FIG. 5

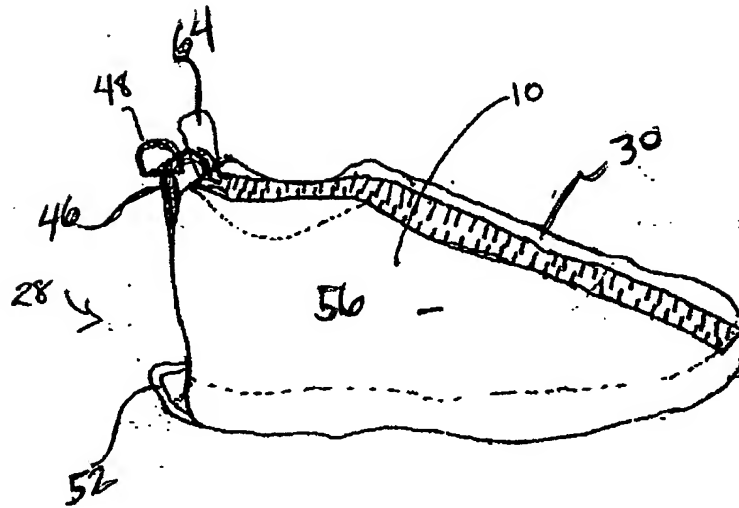
In the Office Action, the drawings were objected to as failing to comply with 37 C.F.R. 1.83(a) for allegedly failing to:

- (1) show the method steps of inserting an article of footwear into the cavity and securing the article by closing the mechanism as claimed in claim 10;
- (2) show the step of sewing the peripheral edge as claimed in claim 12;
- (3) show the step of sewing the mechanism as claimed in claim 13.

Regarding issue (1), the replacement FIG. 5 illustrates the footwear 10 inserted within the cavity 56 of the shoe cover 30. The mechanism 42 is closed to secure the footwear 10 therein.
